Comments Received:

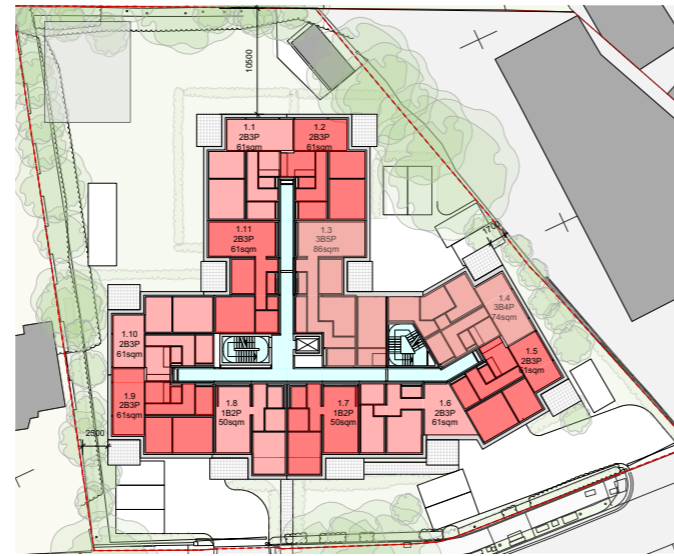
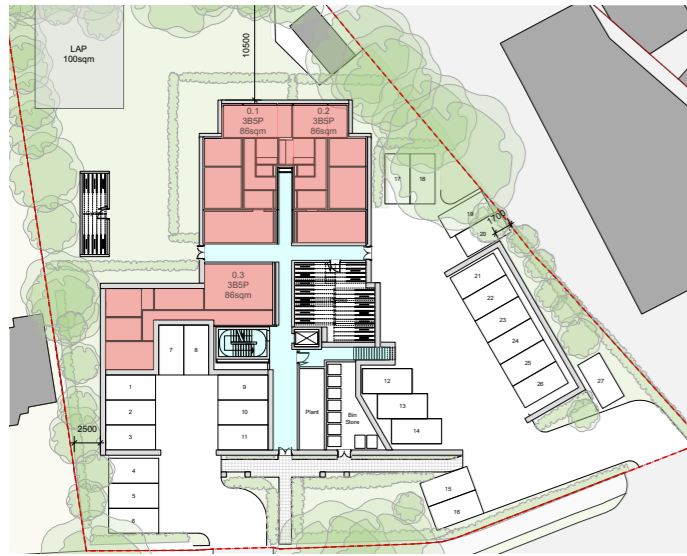
- Single aspect units facing north should be avoided, a high proportion of dual aspect flats should be achieved.
- Having the entire frontage dominated by parking gates etc creates a blank hostile frontage and would not be supported. The Council thus support locating residential accommodation on the ground floor to the front of the site, as long as technical reports support this (air quality, noise levels etc). Two vehicular undercroft accesses is considered too much, one is usually acceptable.
- The communal entrance should be clearly articulated and the lobby shown in the pre-app 2 proposals should be larger. Currently way finding is poor and the main residential entrance is lost in the elevation

- There are no single aspect units facing north. Additional windows have been added to the flats side walls to avoid single aspect as far as possible while taking into account overlooking to the neighbouring properties.
- Building frontage including car park, entrances and landscaping has been revised. There are currently no parking spaces in front of the building. Air quality and noise are also been reviewed to demonstrate GF flats feasibility. One undercroft omitted.

3 Bed

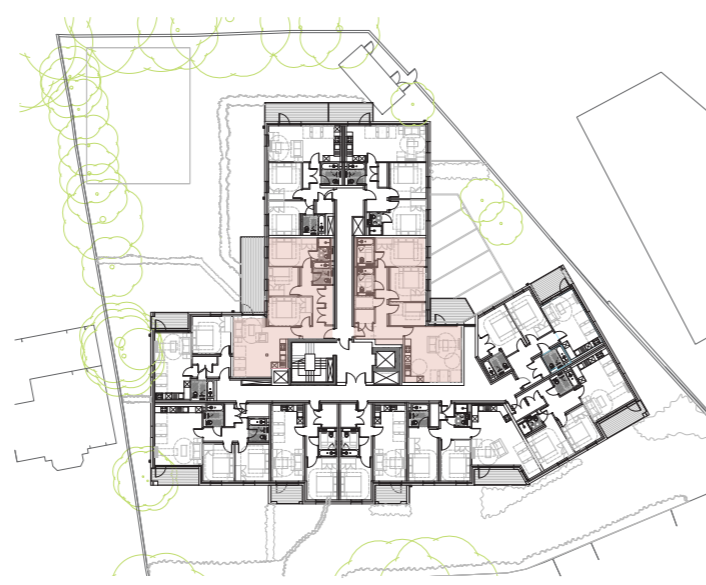
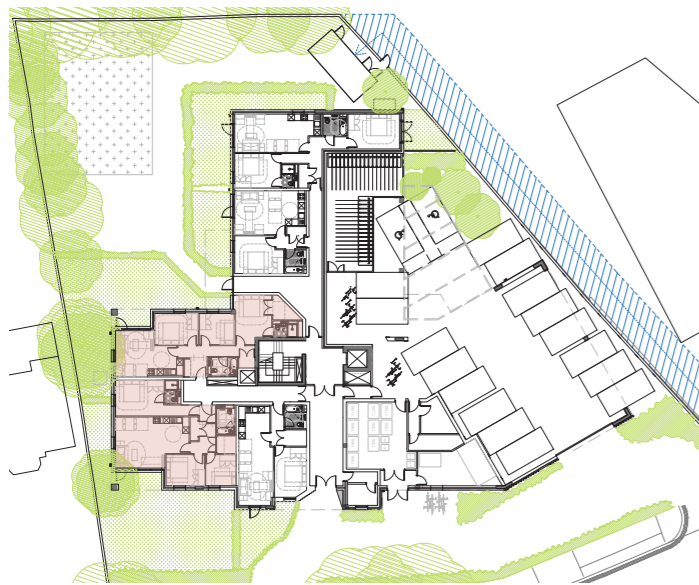
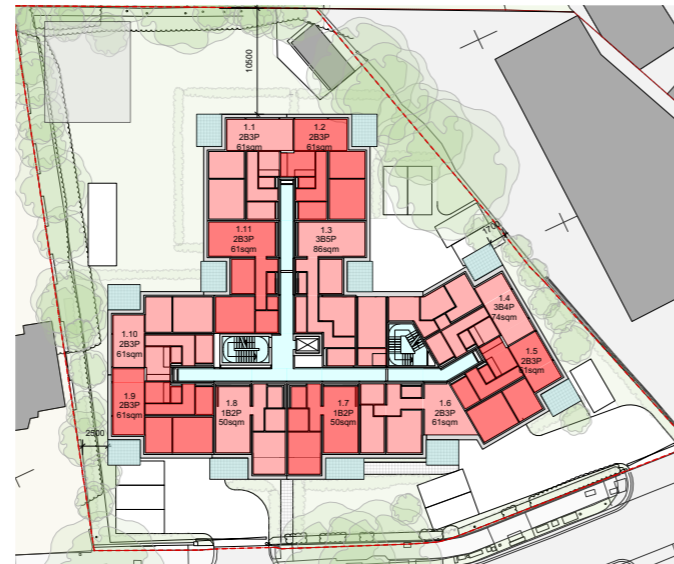
- The proposal should get as close to providing 25% 3 beds as possible, but this will be considered in terms of viability and in the planning balance.
- The highest need in 3 bed units is affordable rent.
- The proposals should provide 50% affordable homes, with 70% of those affordable homes being social or affordable rented housing and 30% being intermediate housing (such as shared ownership or intermediate rent).

- There are 9 no. 3-bed flats in the scheme which is a 21% provision of the total.
- This is what is feasible given the policy constraints e.g. on amenity provision for larger units, and the fact that the scheme is a block of flats.
- The viability / AH offer is going to be tested and agreed with the LPA during the determination period.

Children's' play area
Private amenity space

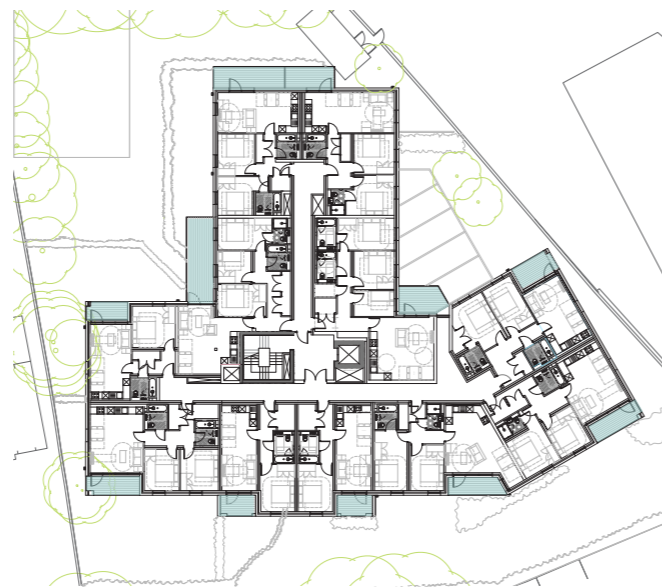
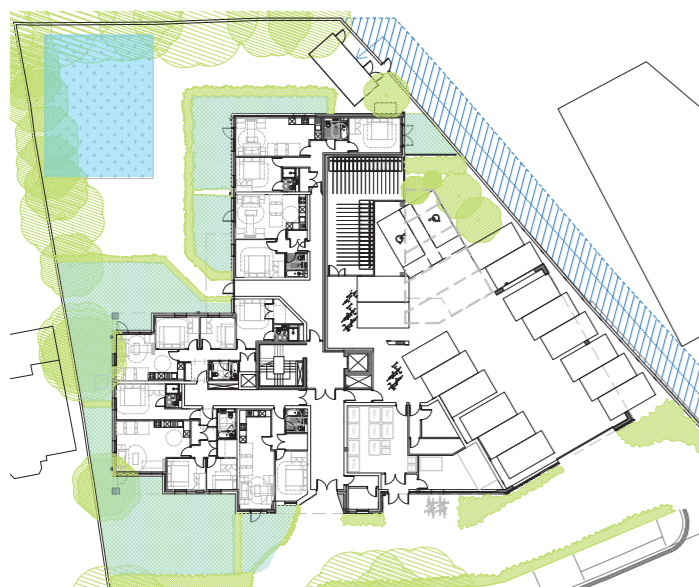
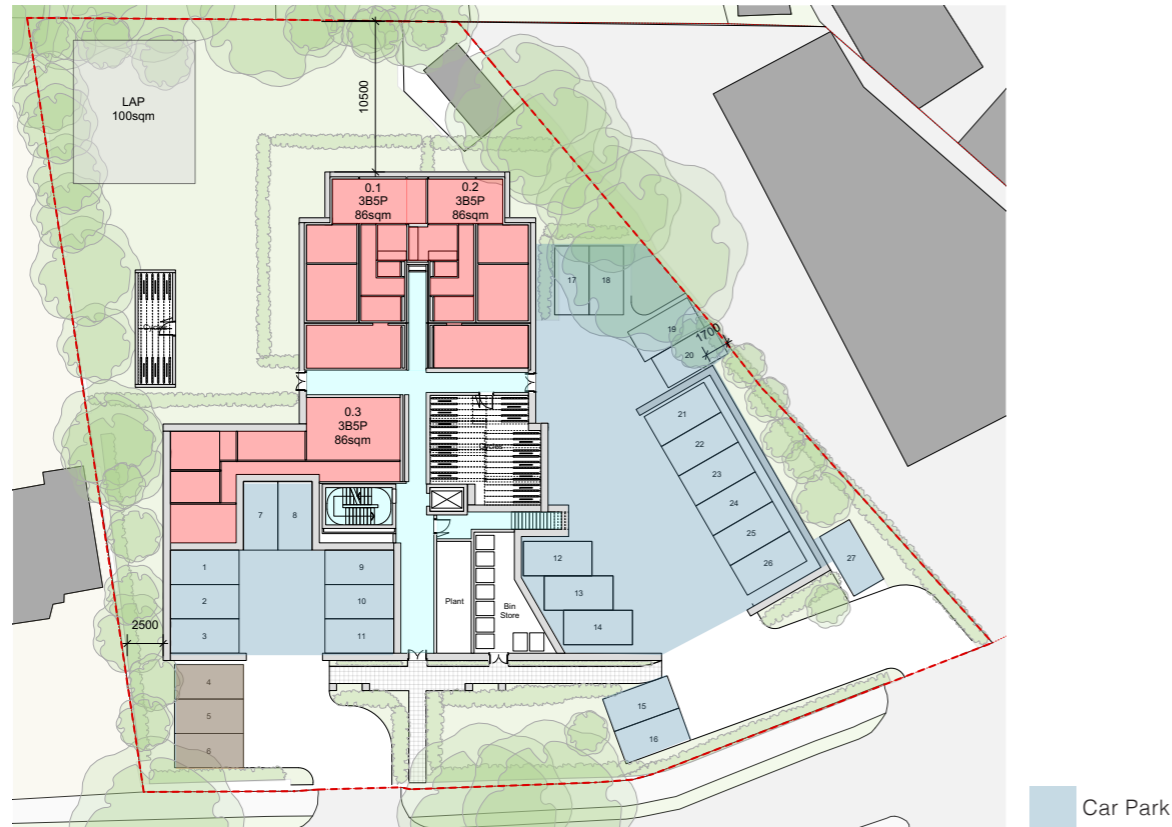
- The private amenity space standards for 3 bed units, regardless of floor level, is 50sqm. The private amenity space standards for 1 or 2 bed units is 20sqm Any shortfall in private amenity space should be offset by communal amenity space. Each balcony/terrace should at least meet London Plan policy D6 standards – i.e. a minimum of 5 m² of private outdoor space for 1-2 person dwellings and an extra 1 m² for each additional occupant, and it must achieve a minimum depth and width of 1.5m.
- On-site play space for children should be included as part of the amenity space offer. 10sqm per child should be provided, this is to be determined using the GLA child play space calculator.

- Private amenity spaces as shown in the current plans comply with both Brent and the London Plan Standards. GF flats have 50m² private amenity space as a minimum. The amenity spaces of the upper floors comply with the London Plan standards and any shortfall is offset by the communal garden at GF and the terraces on the upper levels.
- On site play space for children has been added to the proposals and been determined by the GLA child play space calculator.
- A detailed proposals for the landscape has been put together.

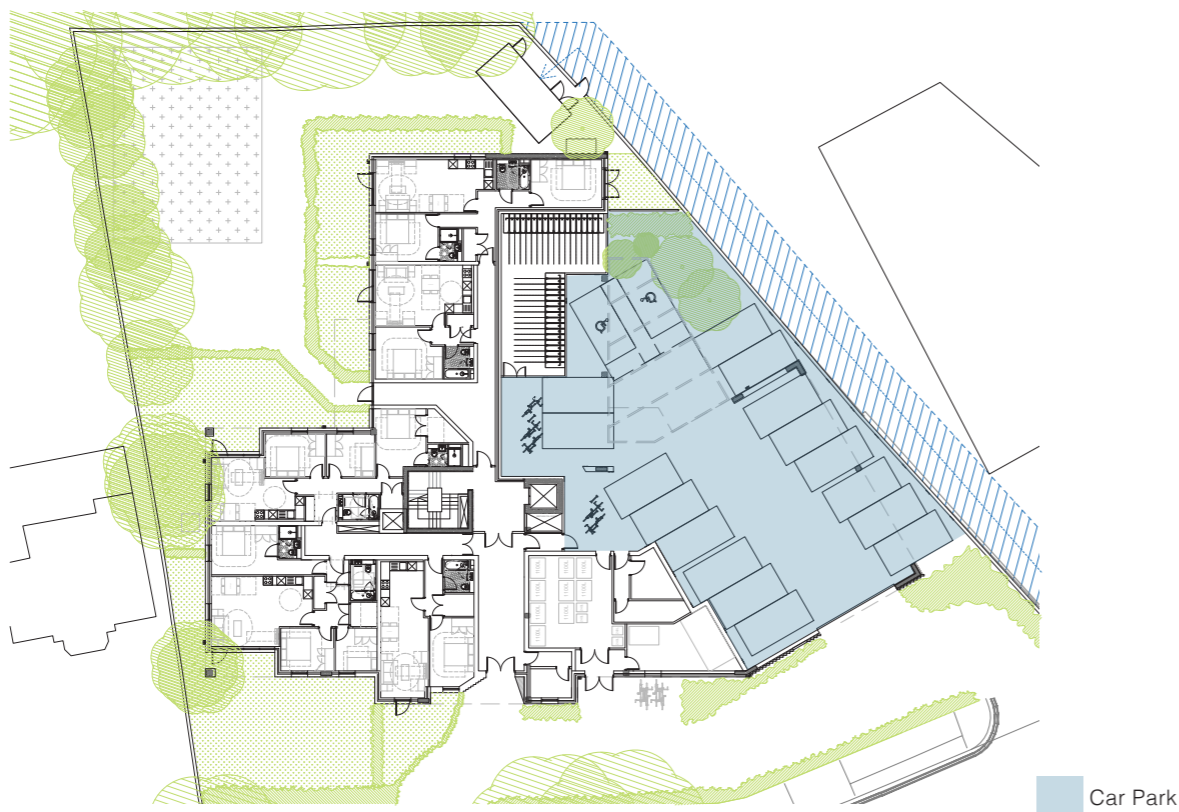
- The proposal should provide 0.75 parking spaces per flat, this is based on expected demand based on census data. A parking survey should be undertaken to determine what level of on-street parking is available. At least 2 disabled parking bays will be needed from the outset.
- Efforts should be made to reduce the level of hardstanding and increase the level of green space and natural amenity space.
- One visitor cycle space would be required as a minimum.
- The pre-app 2 proposals would result in a need for 11 x 1,110l Eurobins. The refuse store shown in the pre-app 2 proposals is approximately 14m from where refuse vehicles could park which is just over the maximum distance, but this could be addressed by providing a more direct footpath to the store from the service road.

- As demonstrated by the parking survey carried out by Waterman, there is capacity in the immediate surroundings of the proposed building to accommodate the cars that cannot be parked within the development, which provides for 18no parking spaces including 1no disabled parking. The London Plan requires 3% of total parking spaces to be provided as disabled parking while Brent Policy requires 10% if all accommodation is private and the proposals reflect this. The car park has been rearranged to provide a more active building frontage and no car parking are proposed in front of the building.

- Green spaces have been maximised to the front of the building.
- Visitor cycle spaces have been provided in front of the building.
- Bin store updated to show required number of bins. Binstore location retained with access from the main facade. Refer to the Waste Strategy submitted as part of the Planning Application.
